Boston Alternative Energy Facility

Worst Case Assessment for Land Raising (Tracked)

Document Reference: 9.77 (1)

Subject: ~~Boston Alternative Energy Facility: Deadline 7 – Worst Case Assessment for Land Raising~~
Boston Alternative Energy Facility: Deadline 9 - Worst Case Assessment for Land Raising

TITLE **BOSTON ALTERNATIVE ENERGY FACILITY DEVELOPMENT CONSENT ORDER Regulation 5(2)(o) - Technical Note - Deadline 7 Worst Case Assessment for Land Raising Figure 1**

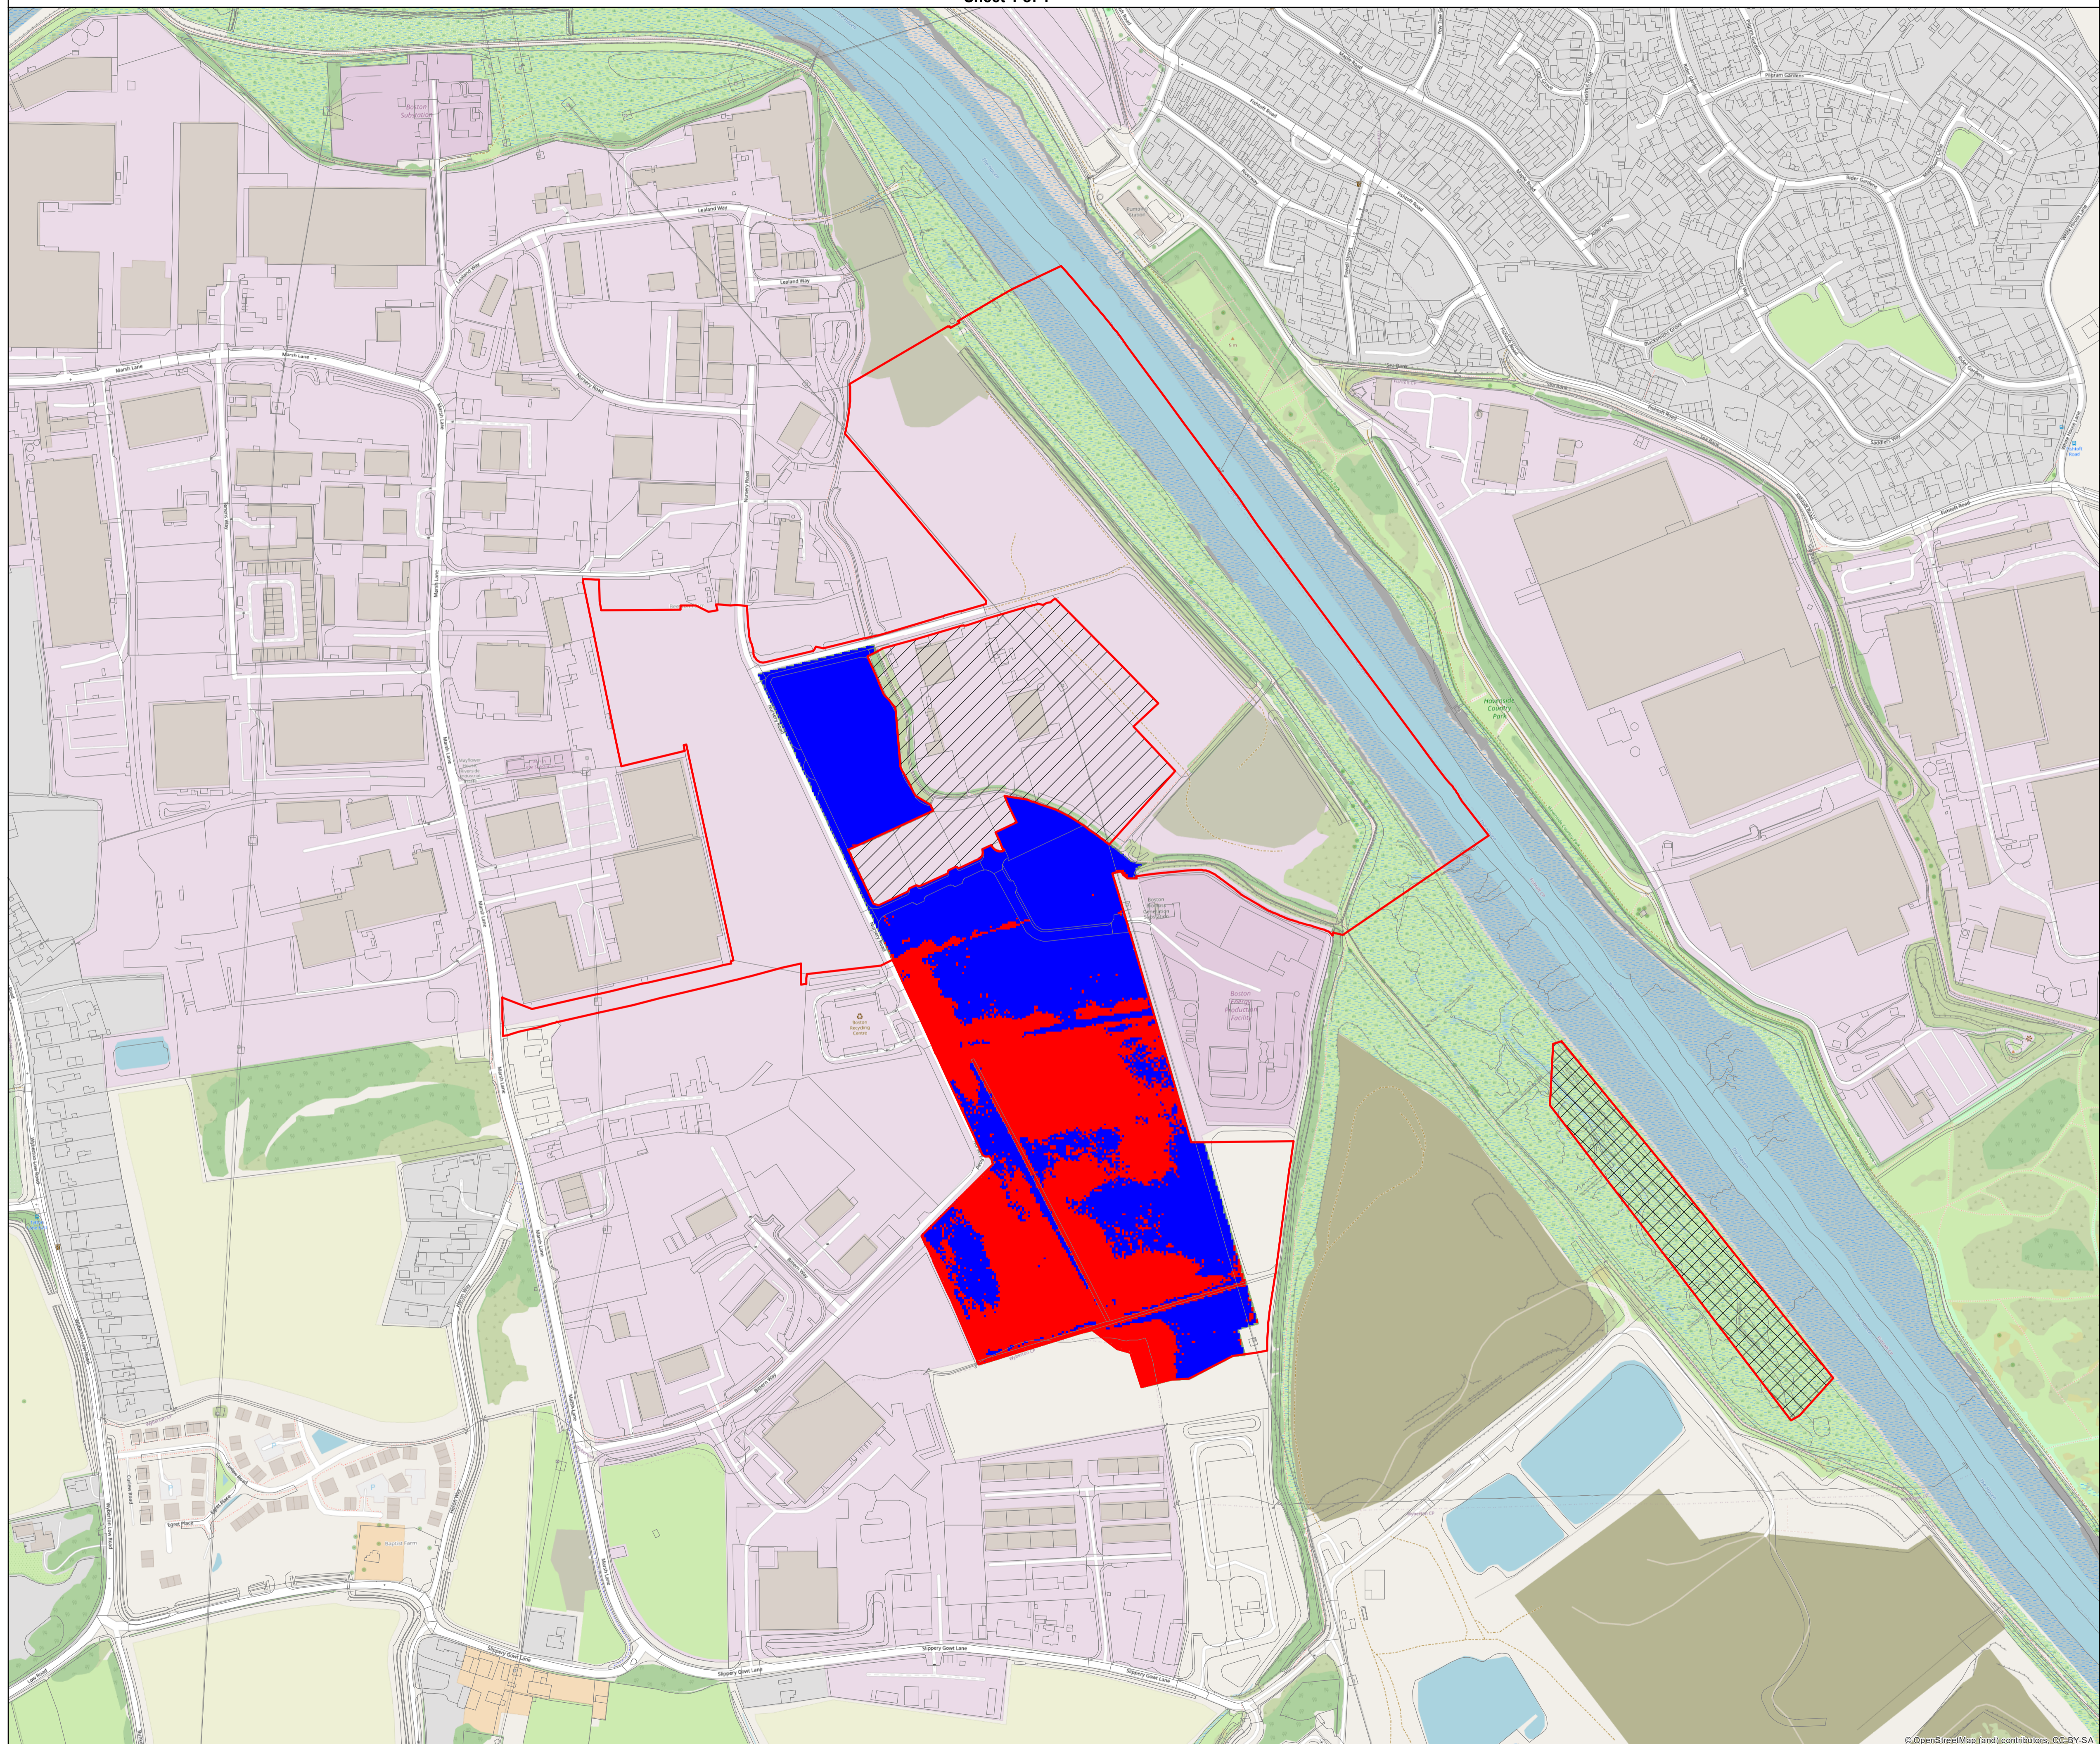
2.4. We have reviewed document ref REP7-009 (Worst Case Assessment for Land Raising). We consider the document is a reasonable assessment of the possible impacts on flood flows as a result of land raising and has addressed some of our concerns. However, the assessment does not include an assessment of works taking place in the area between the proposed wharf and Roman Bank. The assessment must be updated to see what impact (if any) may arise as a result of works in this area.”

4.1.3 Furthermore, it is noted that, in their Deadline 8 submission (REP8-019), the Environment Agency requested the same assessment be undertaken for the land between the proposed wharf and the Roman Bank. However, the Applicant notes that this part of the site has also been omitted from the assessment on the basis that the land in this location will not be subject to the same cut and fill exercise as the Principal Application Site.

4.1.2 As can be seen in **Figure 1**, the land subject to levelling is focused on the Principal Application Site. The land proposed for the construction car parks and laydown areas, to the west and north west of Nursery Road will not be subject to ground levelling. Therefore, these areas have been excluded from the assessment.

4.1.24.1.6 It is on the basis of the above that the land between the proposed wharf and Roman Bank has been omitted from the assessment as no change in ground levels means there will be no reduction in flood storage in this location post-development compared with the existing scenario.

4.1.54.1.10 The results of this assessment confirm that overall the gains in flood storage volume as a result of the decrease in ground levels are likely to be greater than any loss of flood storage volume as a result of increased ground levels. Therefore, it is not expected that there will be any reduction in the volume of flood storage.
